**COMMENTS ON THE 45-DAY EXPRESS TERMS
FOR
PROPOSED BUILDING STANDARDS
OF THE
DIVISION OF THE STATE ARCHITECT (DSA-AC)

REGARDING THE CALIFORNIA BUILDING CODE
CALIFORNIA CODE OF REGULATIONS, TITLE 24, PART 2

2013 CALIFORNIA BUILDING CODE**

**Figure 11B-306.3
Knee Clearance**

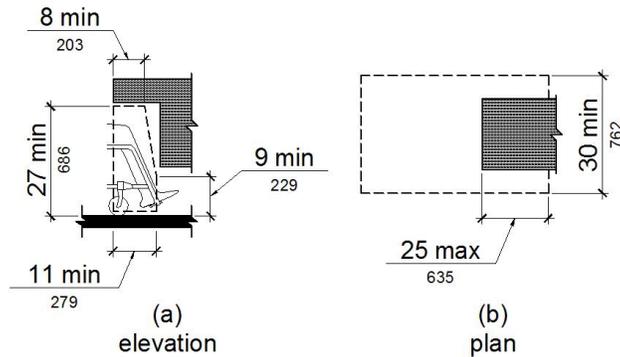
Comment: We oppose this change to seating at tables, counters, etc. which will limit knee depth to 8". This depth is totally inadequate in a drinking/dining situation as a wheelchair user cannot get close enough to the table to prevent spilling food or beverages on their laps. This is further supported by DSA proposing to adopt a full 19" depth at 27" AFF for bars and eating counters. The standard should consistently be 27" AFF minimum height for a minimum depth of 19".

**Figure 11B-609.3
Spacing of Grab Bars**

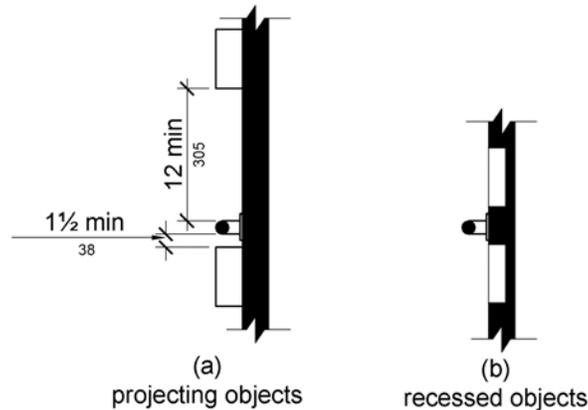
Comment: We oppose this section which would allow the placement of wall mounted items above grab bars located at the side of a toilet. Many people who transfer, or people who are semi-ambulatory rely on having a clear area above the grab bar.
